**NSLPP MEETING HELD ON 01/03/2023****SECTION 4.55 APPLICATION REPORT****Attachments:**

ADDRESS/WARD: 372 Military Road (aka 75 & 75A Parraween Street), Cremorne

APPLICATION No: D269/21/4

PROPOSAL: Section 4.55(2) application seeking modifications to Development Consent (D269/21) including various design changes to an approved five (5) storey mixed use development.

Figure 10: Military Road façade as proposed under D269/21/2

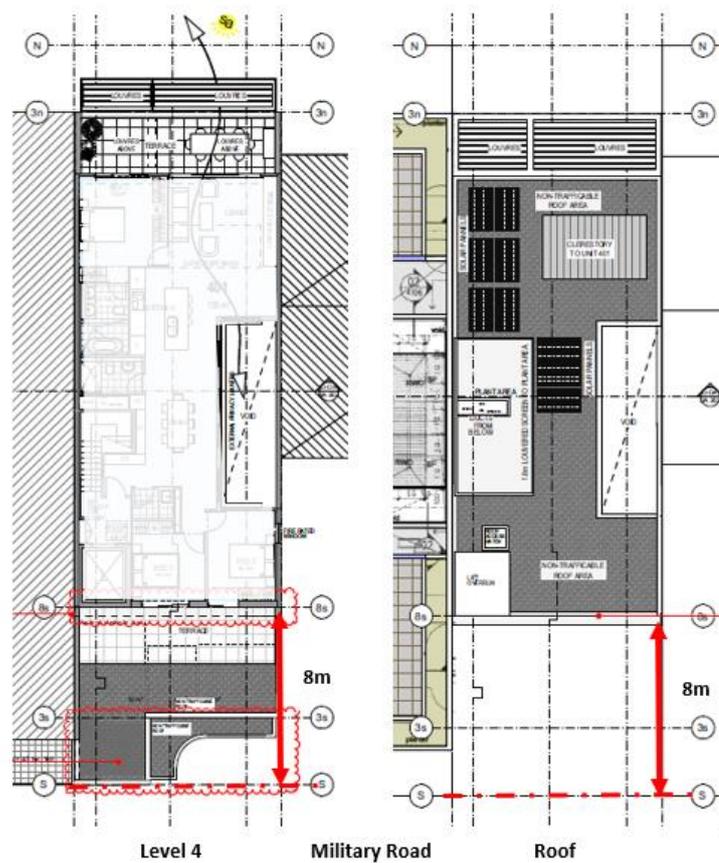
- **21 June 2022** – A section 4.55(2) application (**D269/21/2**) seeking various modifications, including changes to the design for the southern side of the building on Level 4 was lodged with Council (**Figure 10**).

Figure 14: Proposed development and LEP building height limit

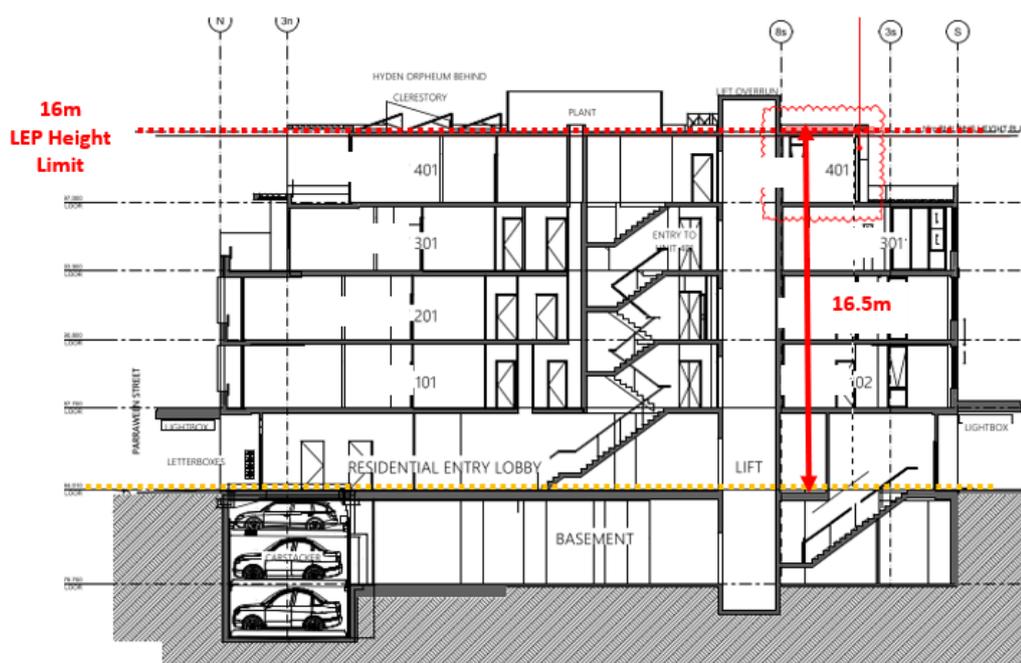
However, the proposed bedroom 3 on Level 4 and its roof slab on the southern side of the proposed mixed use building would cause further non-compliance with the LEP 16m height limit as illustrated below:

The modified building elements in breach of the LEP maximum height limit would be the modified roof slab on the southern side of the building.

There are insufficient environmental planning grounds to justify the proposed changes to southern (Military Road) façade on Level 4.

FOURTH FLOOR 1:100

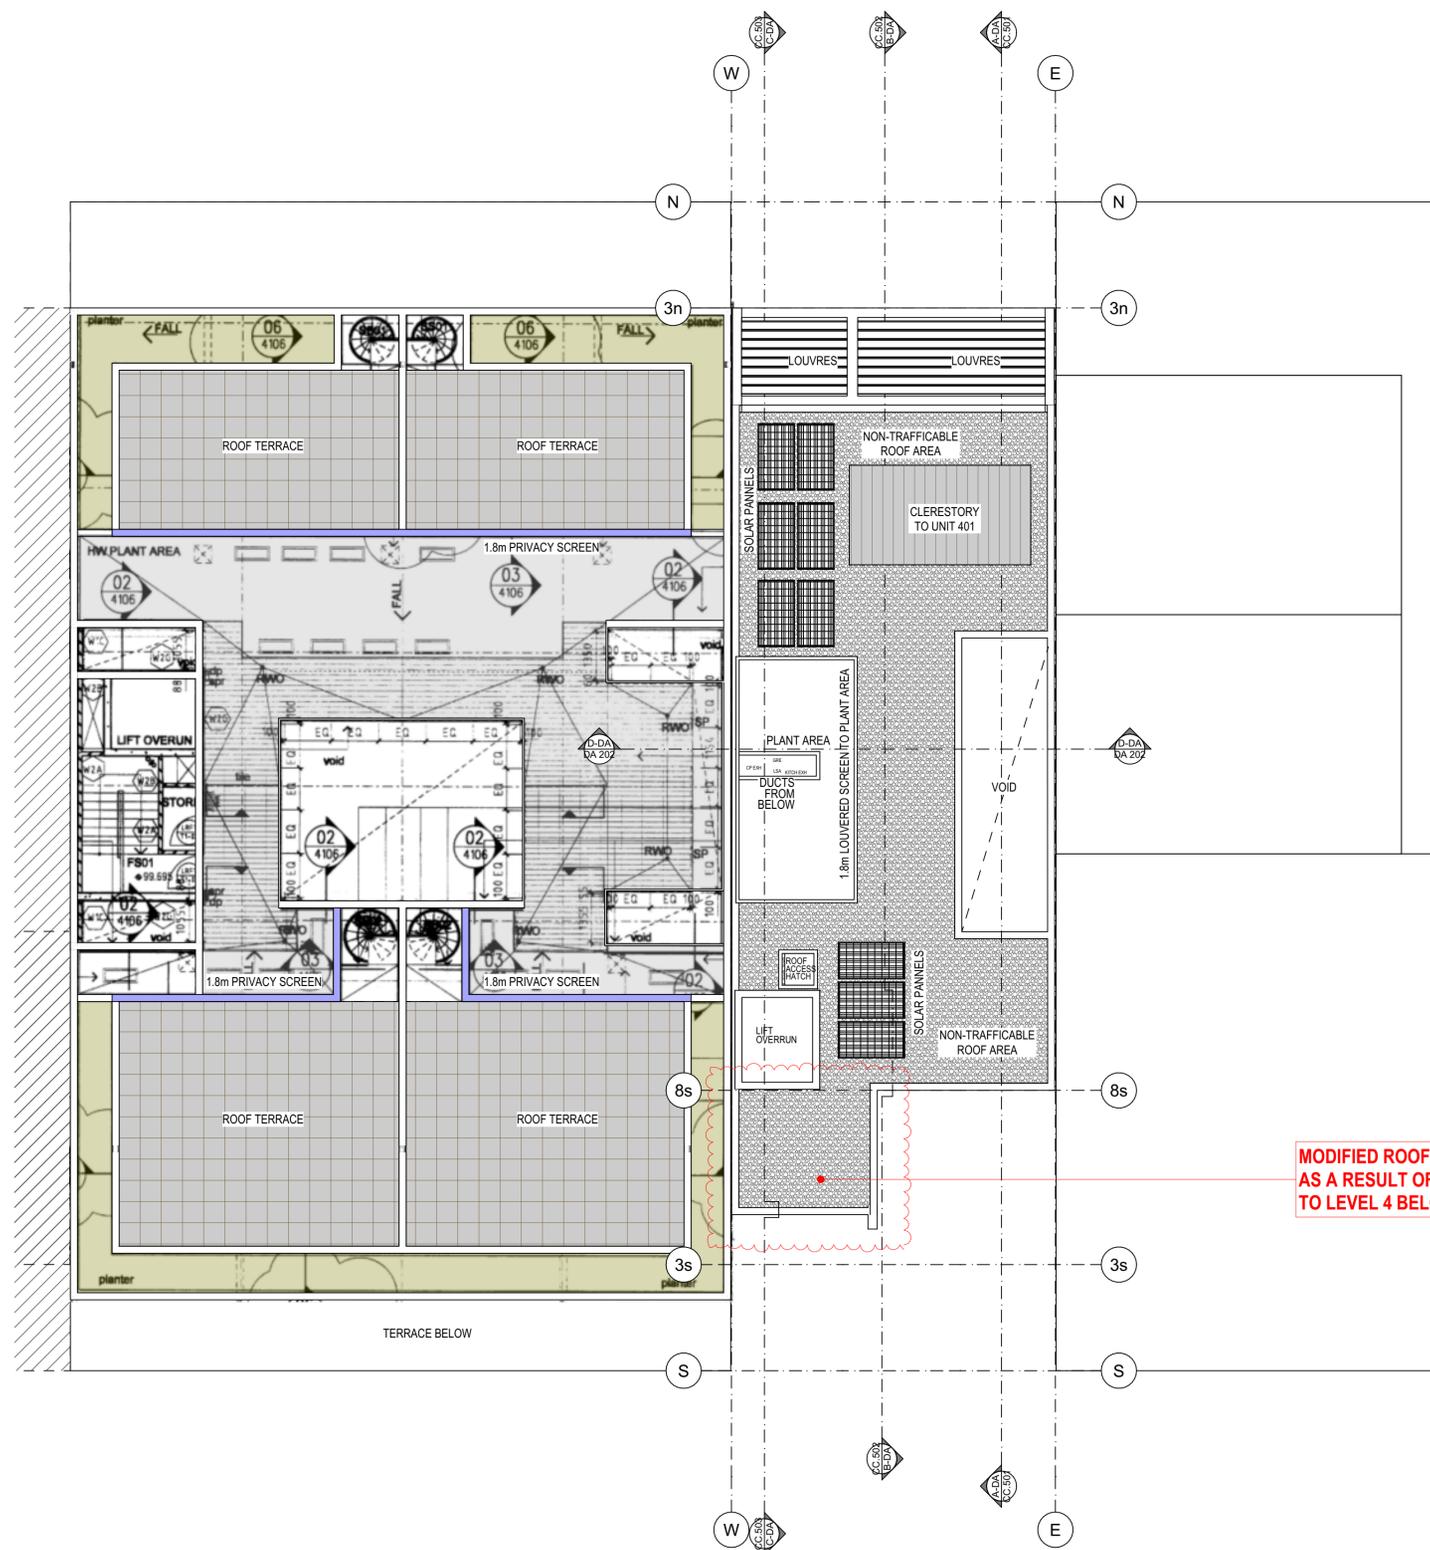
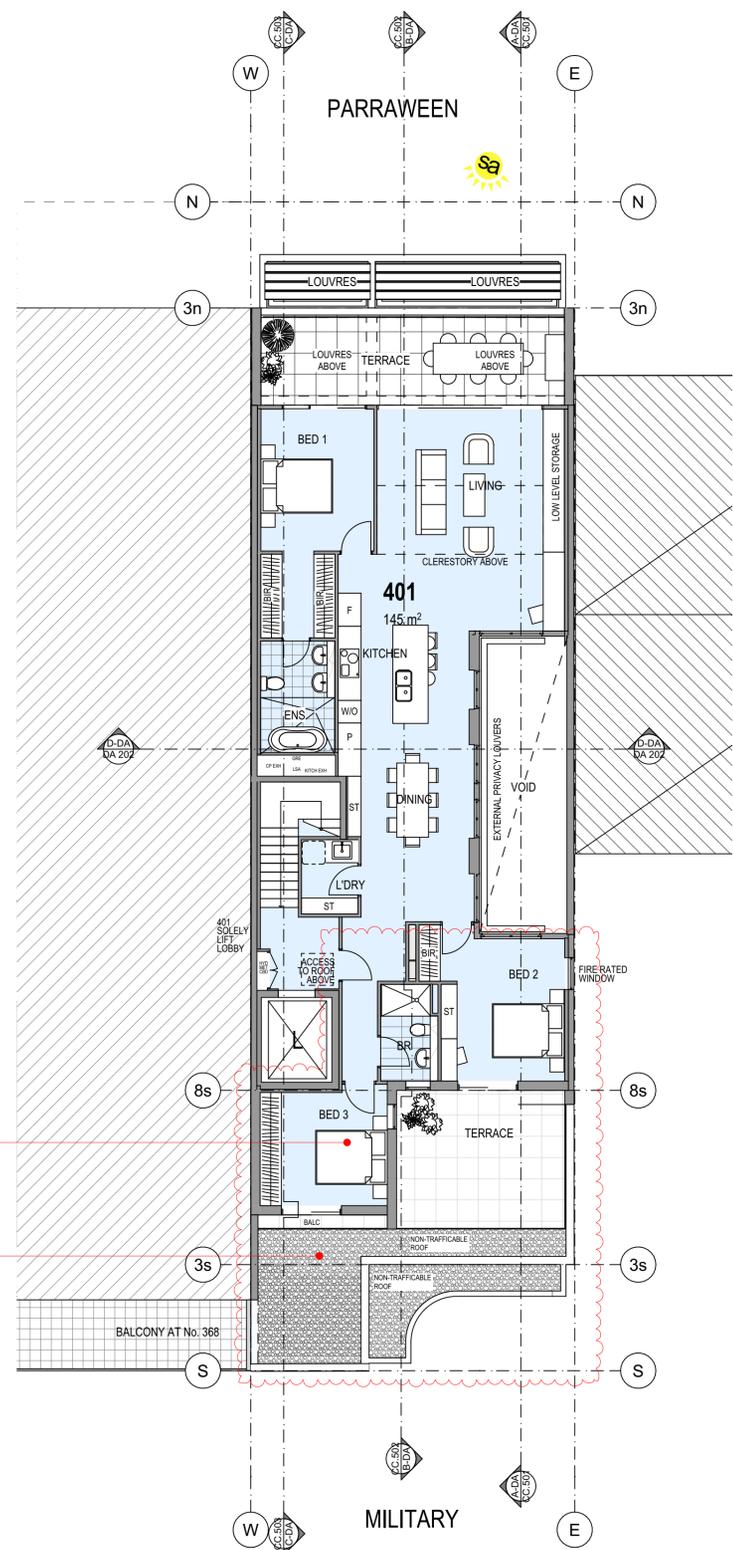
However, the proposed design modifications to the southern (Military Road) façade on Level 4 is not supported because the reduced setback with its stepped form will create visual clutter and will visually compete with the stepped Art Deco parapet wall of the heritage listed Orpheum Theatre. Therefore, this aspect of the subject Section 4.55 application is recommended for deletion from this consent.

The reduced setback with its stepped form will create visual clutter and will visually compete with the stepped Art Deco parapet wall of the cinema which is already negatively impacted by the complex roof additions, ducting and ancillary plant located behind the parapet wall of the cinema when viewed from the west.

- (a) Deletion of Bedroom 3 of the proposed apartment on Level 4 (Unit 401) with the associated eastern and southern walls at this level being set back accordingly;
- (b) The southern building line of Level 4 must provide a minimum 8m setback from the southern (Military Road) property boundary; and
- (c) The design of the southern elevation and the southern terrace for the modified apartment on Level 4 and the internal layout of this apartment, shall be consistent with those as shown on the approved DA drawings (Drawing Nos. DA102 Issue F dated 29 November 2022 and DA301 Issue E dated 21 November 2022, all prepared by PA Studio).
